IMPORTANT SAFETY RECALL NOTICE
NHTSA RECALL 16-E027

April 25, 2016

SERVICE BULLETIN SB-133D
INTAKE STRAINER P/N 010-0030-00-0

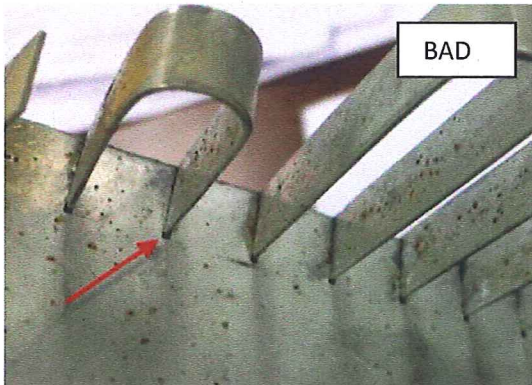
Hale Products is requesting that all of the pumps on the enclosed list in your facility be checked. No special tools or skills are required. Pull suction caps (if installed) and/or any suction adapters off of the intake and check the strainer for faulty soldering. To check the strainer simply remove it from the suction with a pair of needle nose pliers and inspect the back side. If your strainer is missing solder at the joint shown below it is considered defective and a potential risk to safe operation.

If you find that you have received a defective strainer please contact Hale Products Customer Service Center at 1-800-533-3569 or halecustomerservice@idexcorp.com and our Customer Service Representative will send a free replacement directly to the address you specify. Please have the pump serial number available for tracking purposes and be prepared to send a picture of the strainer. For pumps in your stock we are authorizing .25 hour at standard Hale warranty rate.

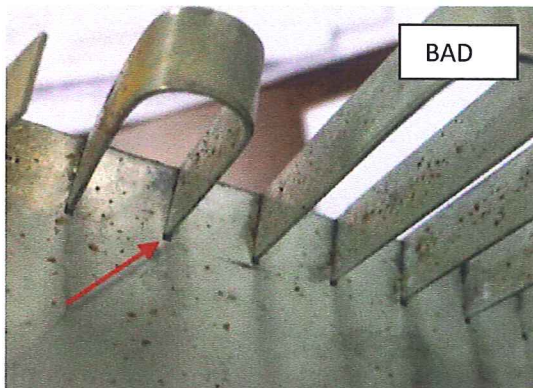
As part of your normal daily checks Hale Products is requesting that you pull caps and any suction adapters off of the intake and check the strainer for faulty soldering. To check the strainer simply remove it from the suction with a pair of needle nose pliers and inspect the back side. If your strainer is missing solder at the joint shown below it is considered defective and a potential risk to safe operation.

If you find that you have received a defective strainer please contact Hale Products Customer Service Center at 1-800-533-3569 or halecustomerservice@idexcorp.com and our Customer Service Representative will send a free replacement directly to the station or the address you specify. Please have your pump serial number available for tracking purposes and be prepared to send a picture of the strainer. Since strainer inspection should be part of the normal checks on your apparatus we are not providing warranty coverage for labor.
